FLYING HORSE NORTH FILING NO. 3
CONSTRUCTION DOCUMENTS

AS-BUILT VERSION 1.0, DATED 7/15/2026
PE: RICHARD LYON
CO PE NO. 53921

FLYING HORSE NORTH FILING 3
PRI #2, LLC.
EL PASO COUNTY, CO

CONSTRUCTION DOCUMENTS
POND A OUTLET STRUCTURE DETAILS

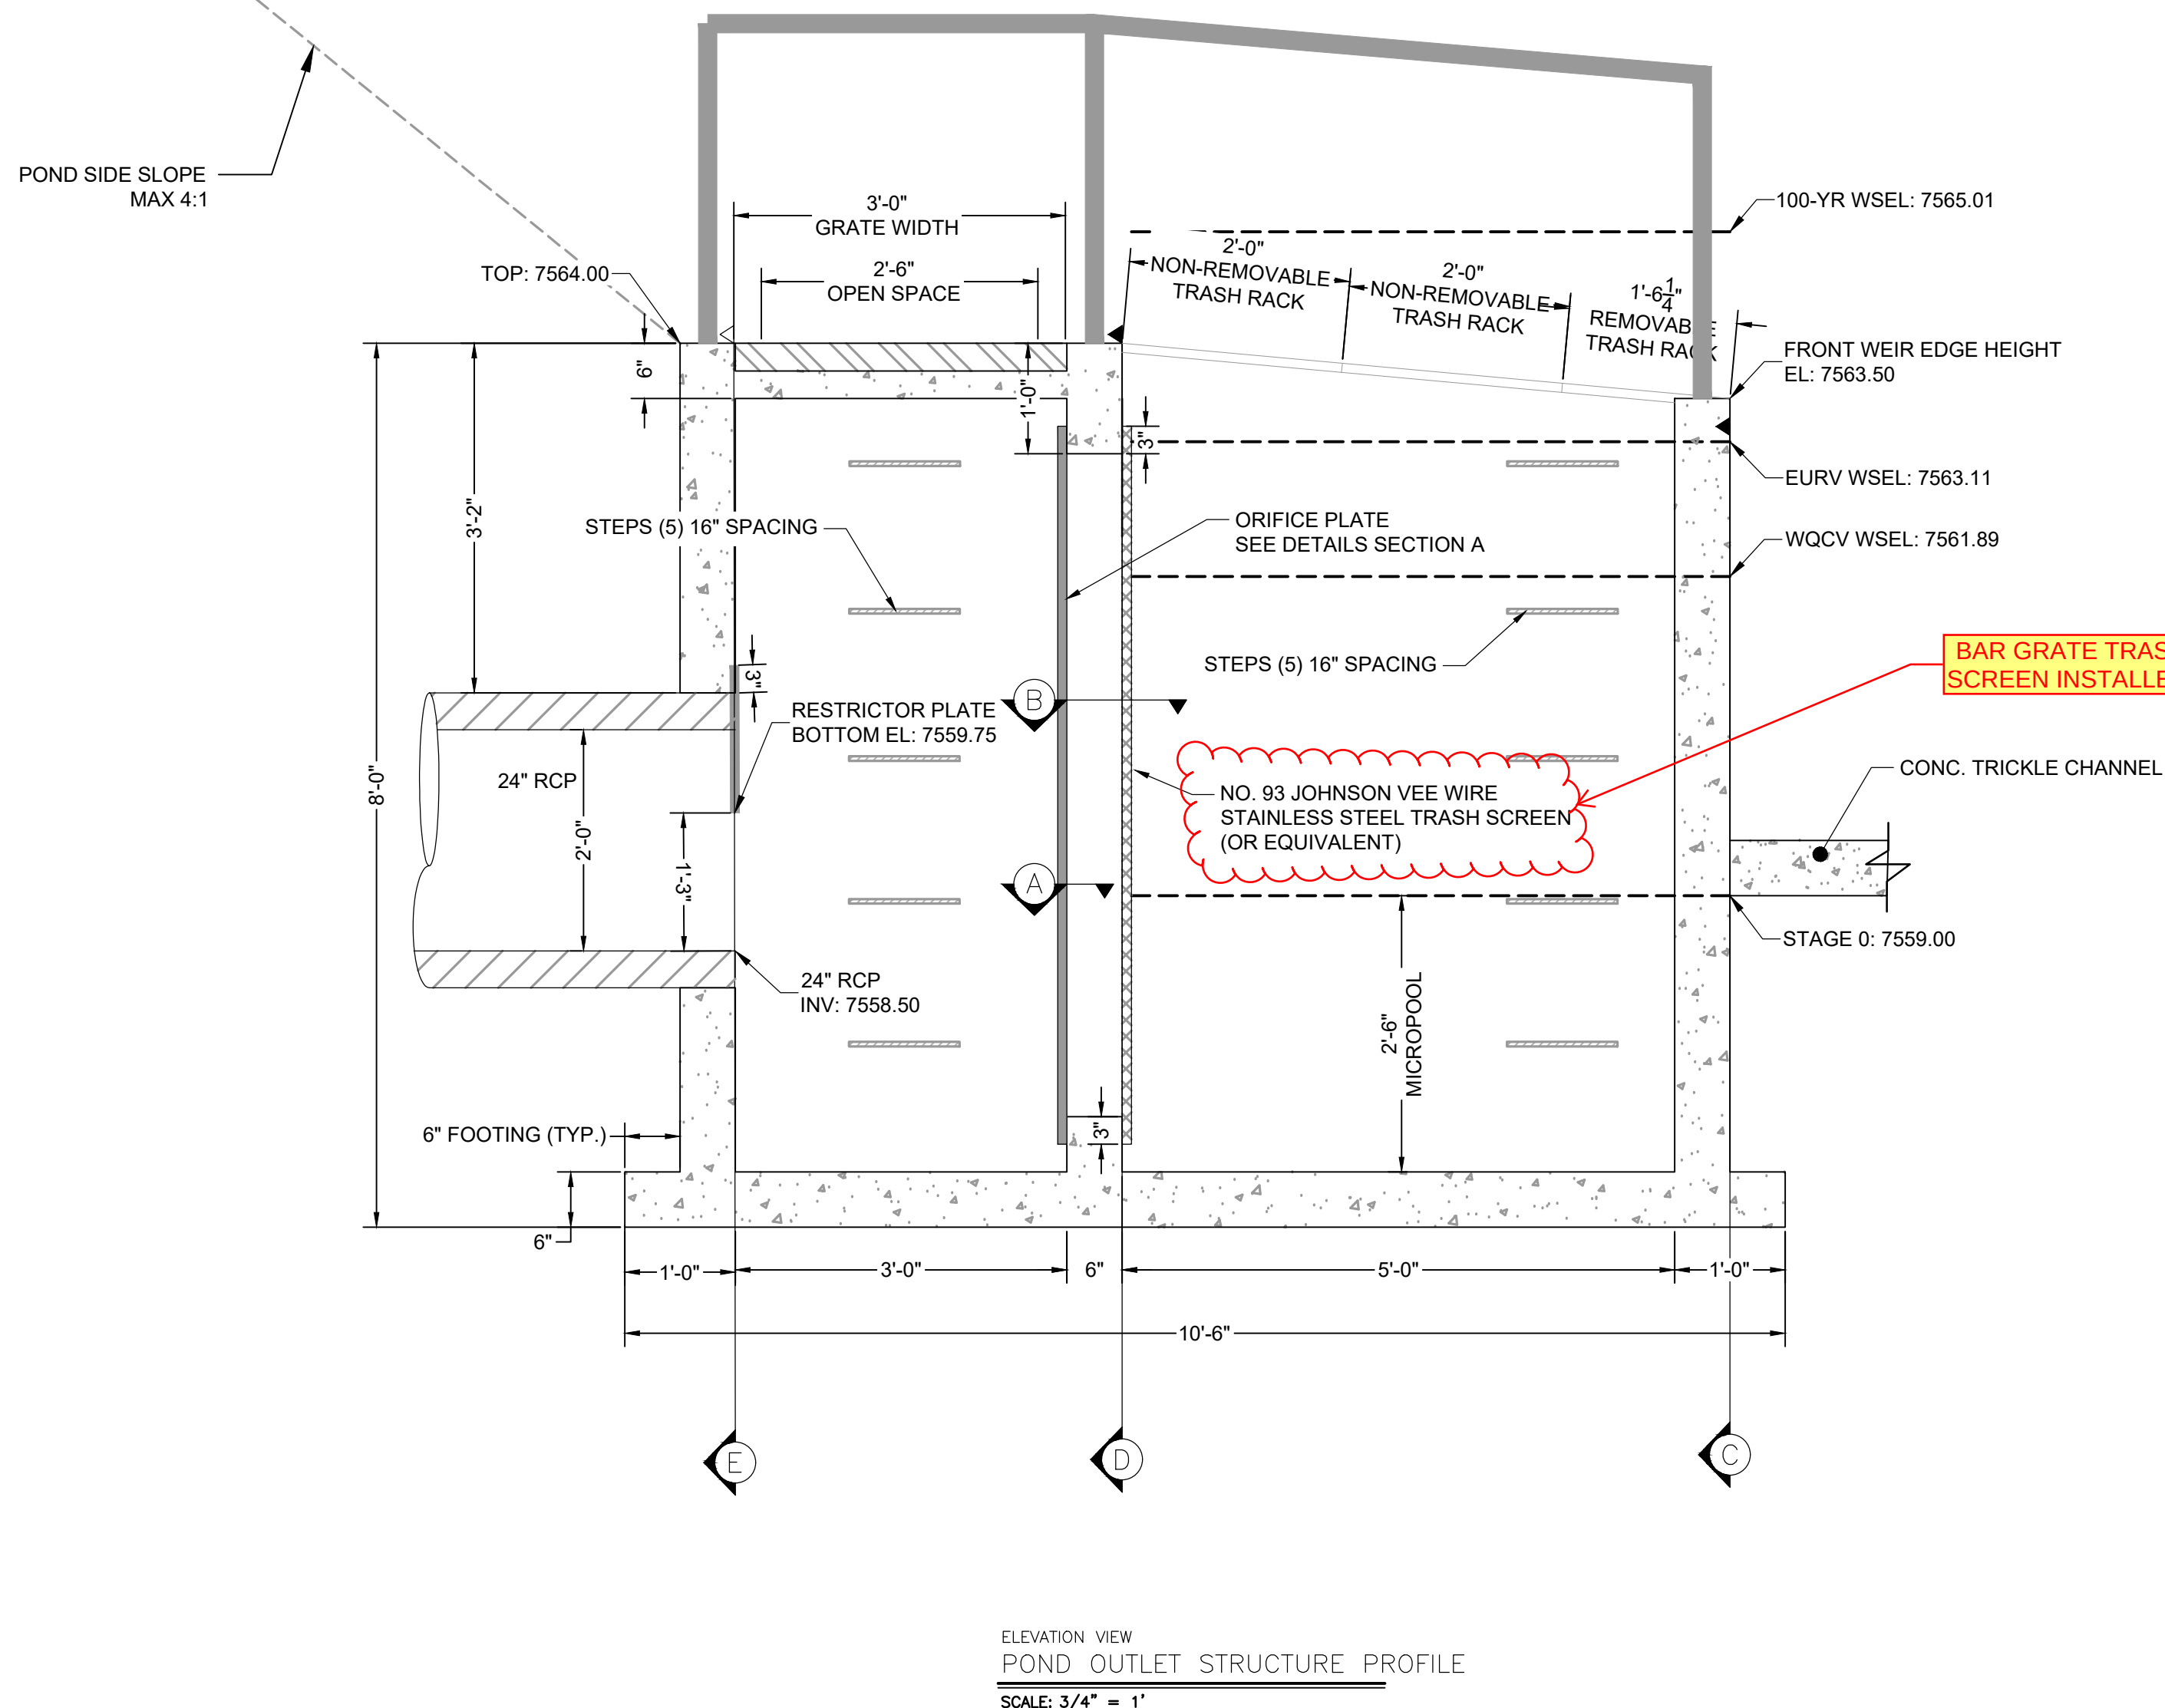
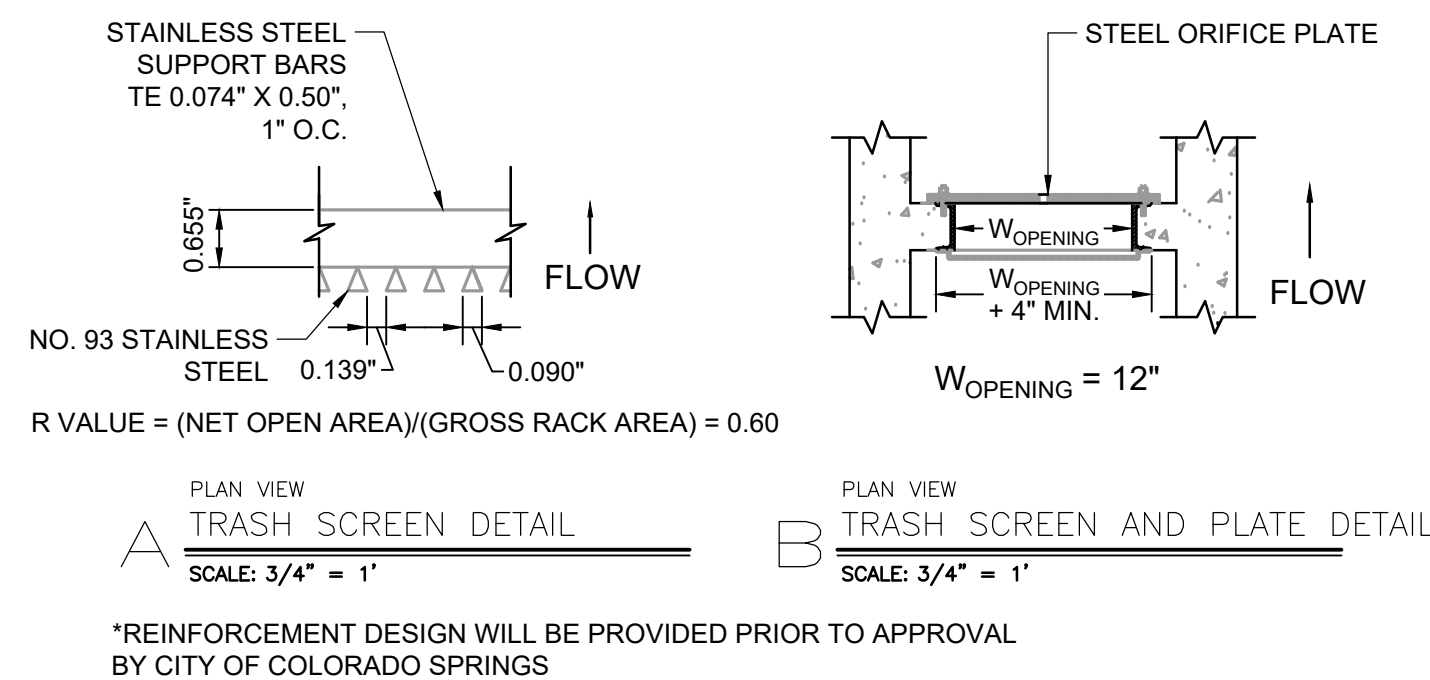
SHEET 26:
- RETROFIT CHANGES FROM CDR259 FOR FUTURE CLUBHOUSE DEVELOPMENT. SEE MODIFICATIONS COPIED IN THE IMAGE.
- SILT REMOVED FROM MICROPOOL
- LADDER STEPS INSTALLED IN MICRPOOL STRUCTURE
- EMERGENCY SPILLWAY DIMENSIONS AND SIZING VERIFIED
- EMERGENCY SPILLWAY SOIL RIP-RAP VERIFIED IN PLACE
- POND SIGN INSTALLED AT SITE
- ORIFICE PLATE VERIFIED
- WATER-TIGHT GASKETS INSTALLED ON PLATE
- AS-BUILT BAR GRATE TRASH SCREEN AND RACKS

SEE CDR259 FOR UPDATES TO ALL POND A INFRASTRUCTURE, GRADING, SPILLWAY, ETC.

SHEET
PND 29

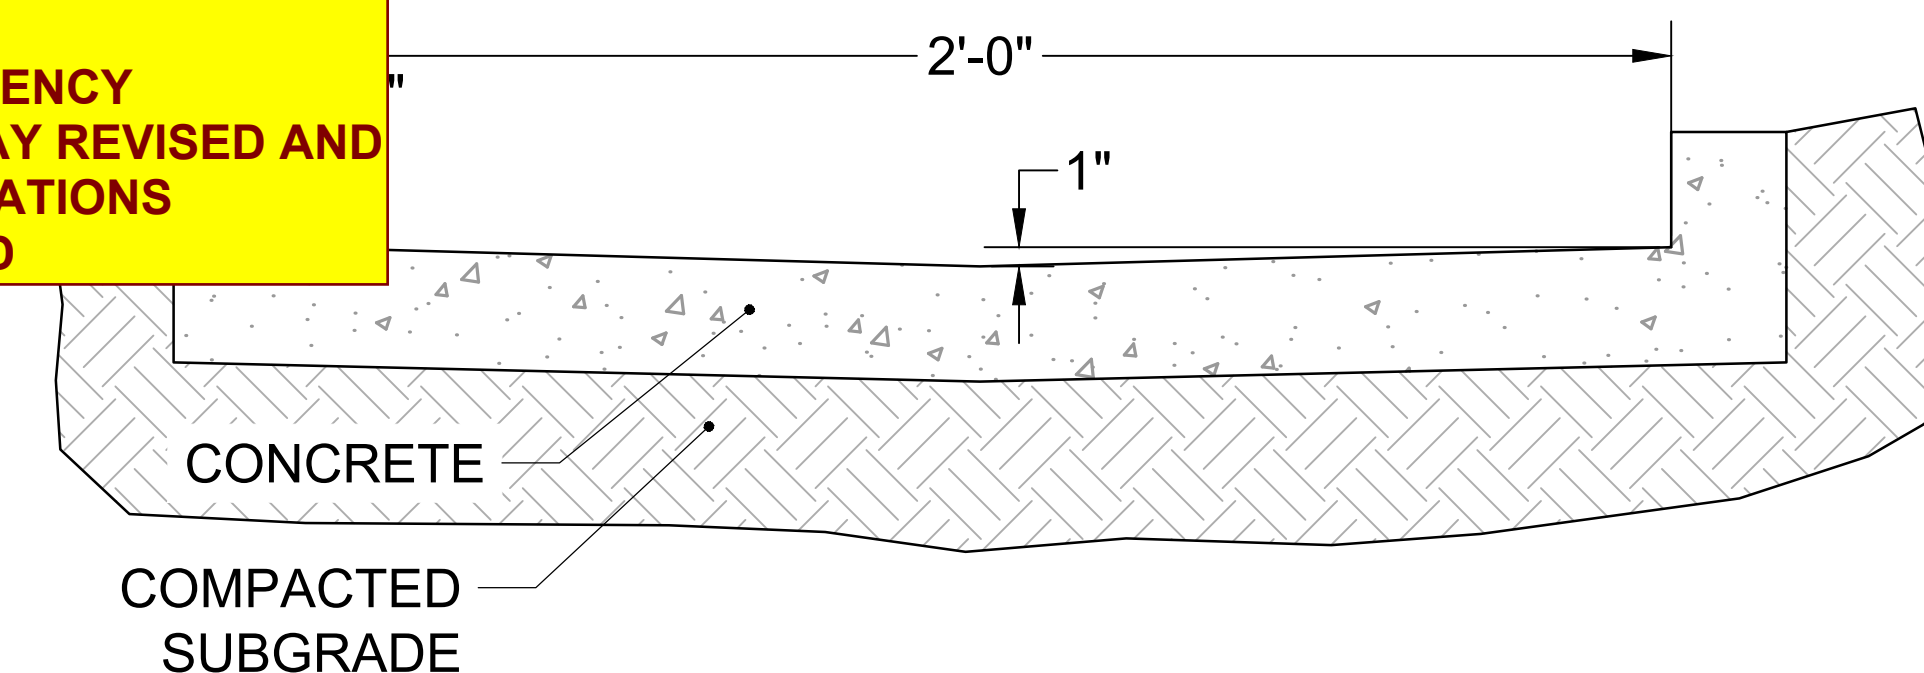
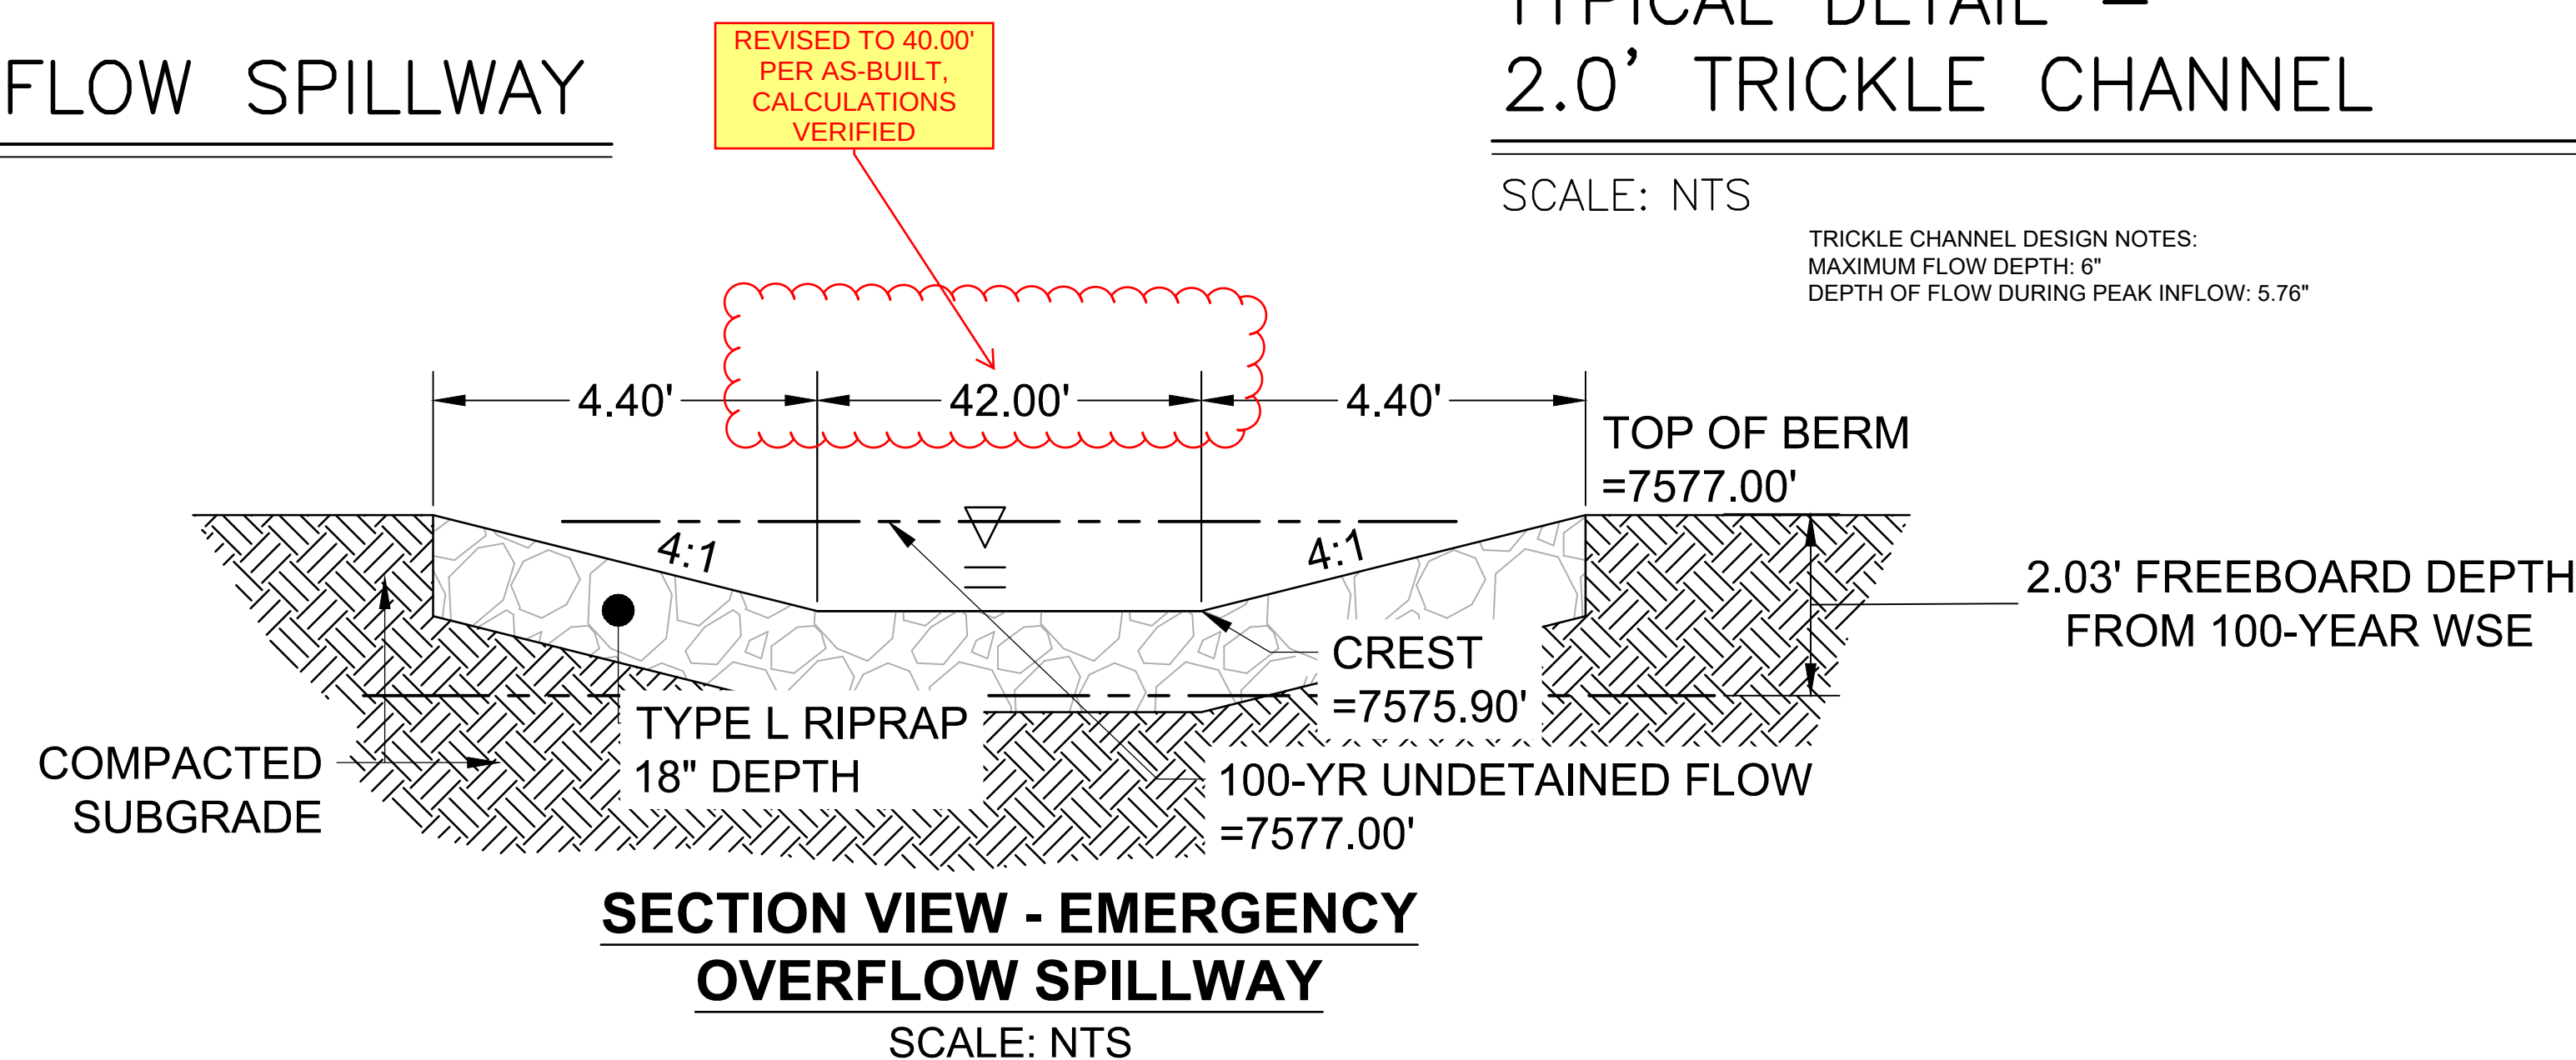
SHEET 29:
- SOIL RIP-RAP VERIFIED
- TOPSOIL IN SECTION
VIEW REMOVED
- CRUSHED CONCRETE
POND MAINTENANCE
ACCESS
- EMERGENCY
SPILLWAY REVISED AND
CALCULATIONS
VERIFIED

ELEVATION VIEW
 ORIFICE PLATE DETAIL
 SCALE: 3/4" = 1'

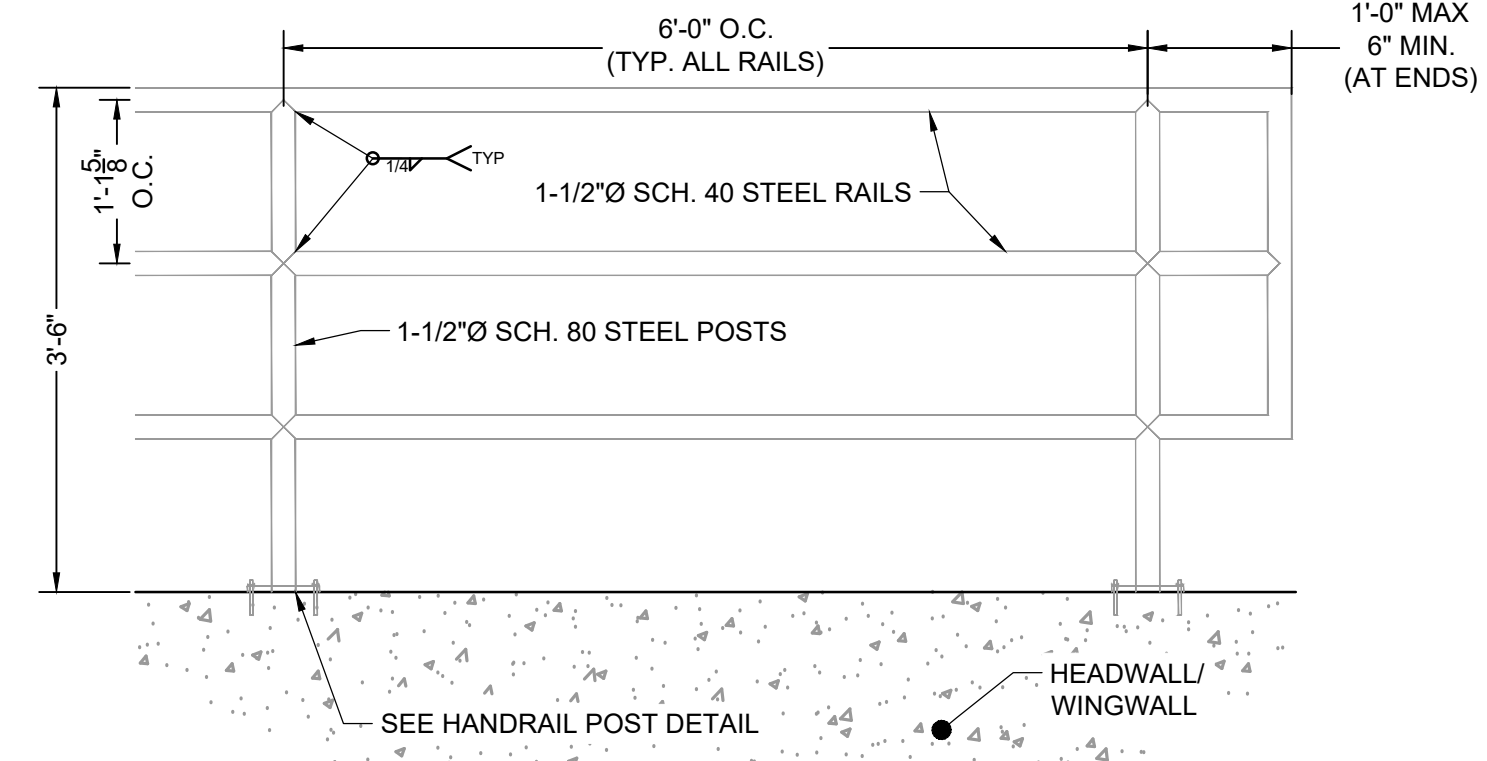
ORIFICE PLATE WAS REVISED PER AS-BUILT DATED SEPTEMBER 24, 2024. REVISED PLATE CALLS FOR:

ORIFICE #1: STAGE 0 ORIFICE OF 1.98 SQ. INCHES (13/16" RADIUS)
ORIFICE #2: STAGE OF CENTROID @ 0.50 FT. FROM STAGE ZERO, SIZE OF 1.98 SQ. INCHES (13/16" RADIUS)
ORIFICE #3: STAGE OF 3.5 FT. FROM STAGE ZERO, SIZE OF 10 SQ. INCHES OR RECTANGULAR SLOT OF 6" WIDTH BY 1.67" HEIGHT.
